**DOMUSEA DEVELOPMENTS
PROPOSED RESIDENTIAL ACCESS
ARRANGEMENTS - CLAYS FARM,
NORTH END ROAD, SUSSEX**

STAGE 1 - ROAD SAFETY AUDIT

JULY 2018

APPENDIX B: Reference Plan

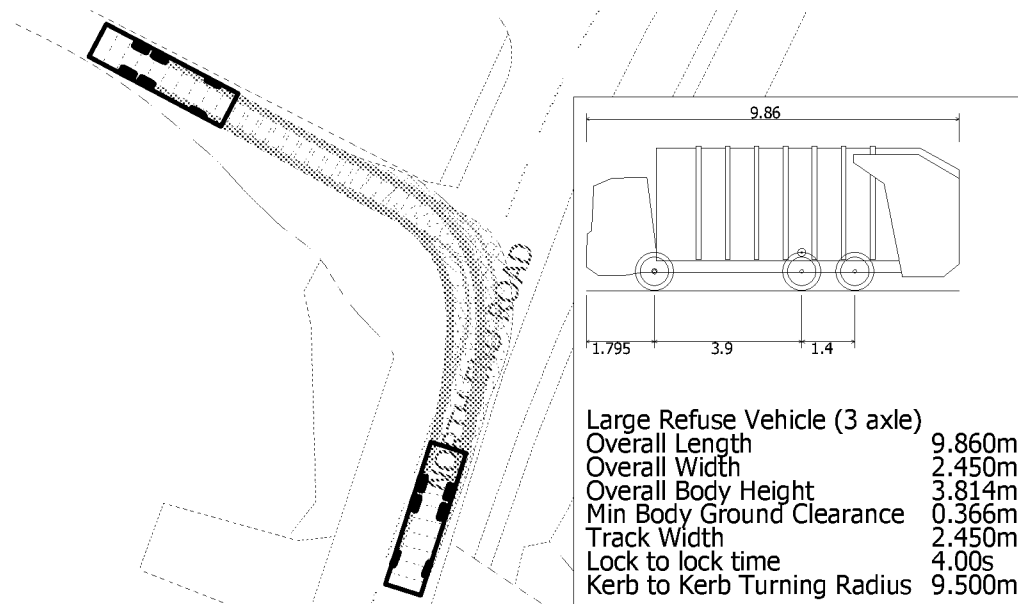
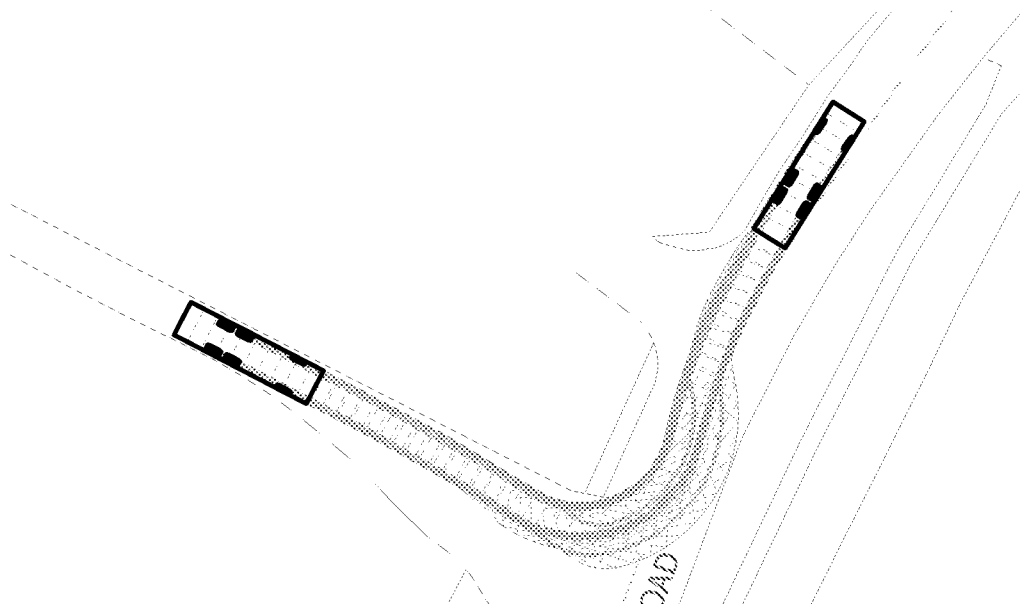
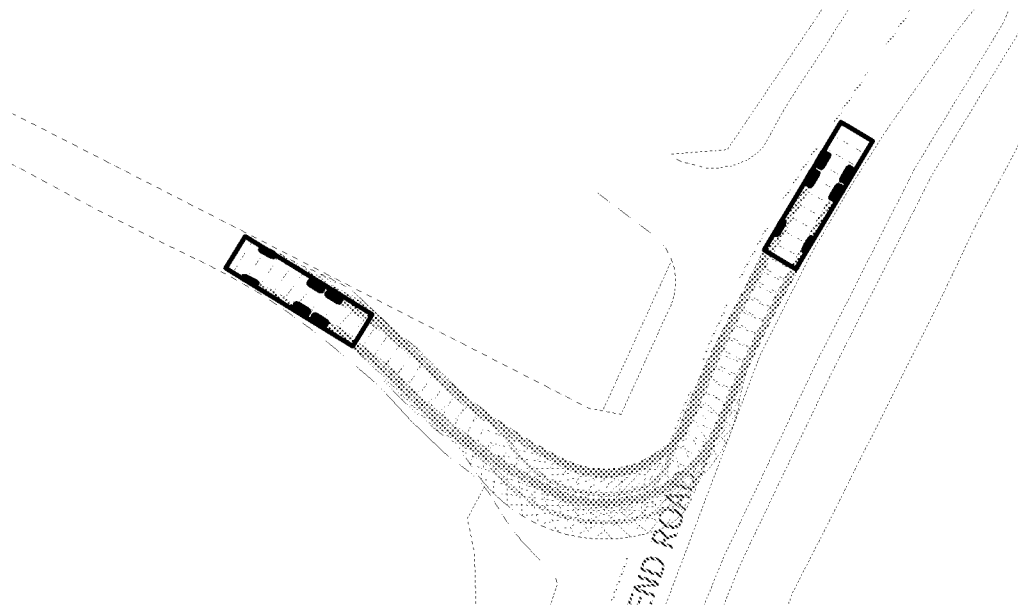
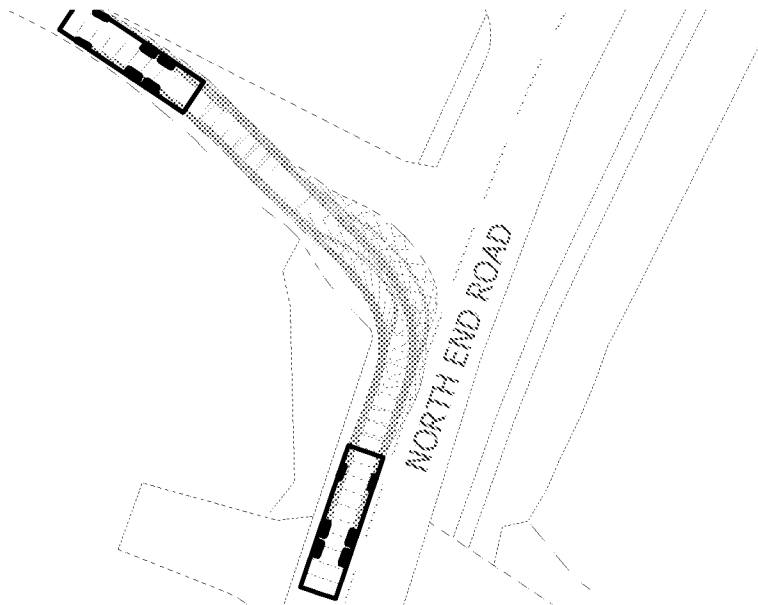
Location: Site access/North End Road (please refer to reference point 2.6 in **Appendix B**)

Summary: Insufficient pedestrian facilities

North End Road is provided with a footway on the eastern side only adjacent to the site access. Therefore pedestrians entering/leaving the development are likely to cross North End Road adjacent to the site access, rather than walk in the carriageway on the western side. For this reason it be important to ensure pedestrians leaving/entering the development site are able to cross North End Road safely and without trip hazards.

Provide sufficient footway on the western side of North Road to enable pedestrian to wait for a gap in the traffic to cross. So as to create a crossing point, this footway should be provided with dropped kerbs and tactile paving. Dropped kerbs and tactile paving should also be provided immediately opposite on the eastern side of North End Road, linking the crossing point to the existing footway.
